INDEX TECHNICAL SERVICE BULLETIN

PRODUCT:
ABBOTT SPECTRUM® CCx(TM) (63)

SUBJECT: TSB#: 63-034A

New Style Pump and Valve / Home Station Interface PCB

Figure 2

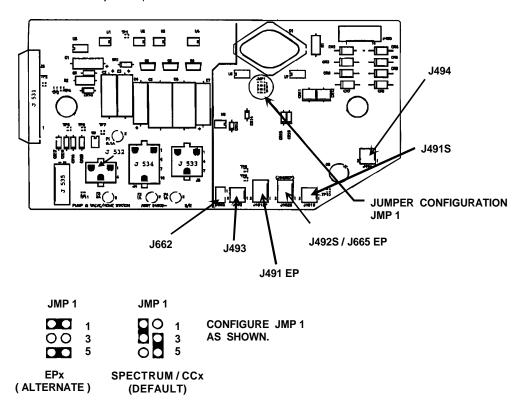
- 7. On the ISE shroud install the correct standoffs as indicated in Figure 1.
- 8. Ensure that the jumper configuration is correct by comparing the new board to the jumper illustration in Figure 2.

Figure 3

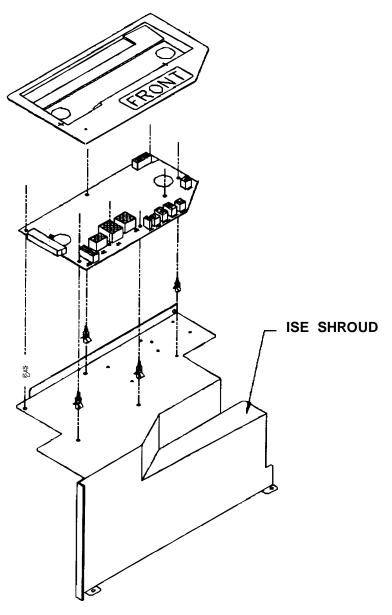
- 11. After connecting all of the plugs to the jacks install the shield over the Pump and Valve / HomeStation PCB as illustrated in Figure 3.
- → 12. Remove the mix arm from the instrument. Allow the mix arm to come to room temperature then using a DVM measure the resistance between the pins of the mix arm. If the resistance is less than 2400 ohms, discard the arm. Replace it utilizing parts from the field service kit.

Figure #1

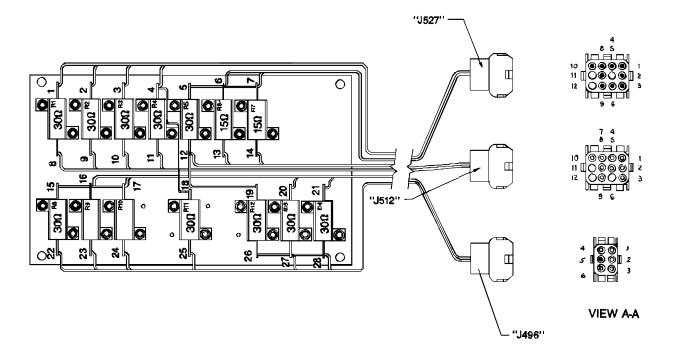
B. HEAT SINK ASSEMBLY (06586-201) Reference Figure 1.

The resistance value for R9 and R10 were 15 ohms. These two resistors are now 7.5 ohms. This will increase the motor torque by increasing the drive current.

Figure #2 Front View

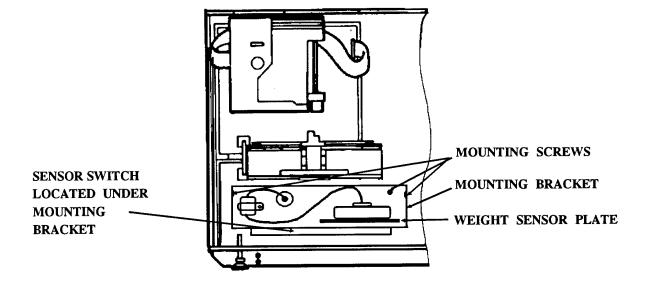
- 6. Disconnect from the pump and valve board P-531 (ribbon cable from motor controller #5), P-532 (lower 24 vdc distribution board), P-535 (high and low pressure sensor and reagent wash manifold), P-533 (reagent ID motor and sensor) and P-534 (115 VAC).
- 7. Remove the 4 nylon standoffs or the 4 hex screws and standoffs holding the Pump and valve board to the ISE shield. Discard the standoffs or the screws and standoffs. Save this board for installation on the new ISE shield.

Figure #3 Top View

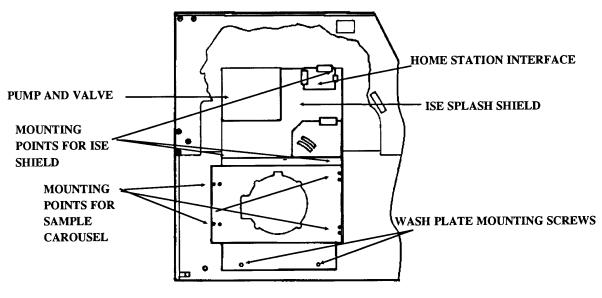
- 8. Disconnect from the Home Station Interface board. P-490 (motor controller #2), P-491 (resistive current limiter), P-493 (carousel home station sensor), and P-494 (24 vdc supply).

- 12. Remove the left back panel of the CCx[™] in order to have better access to the ISE shield assembly.
- 13. Remove the ISE shield assembly, by removing the two hex screws holding the bottom of the shield to the base of the CCx[™] and the one screw that supports the top of the shield to the shelf above it (Reference Figure 3).
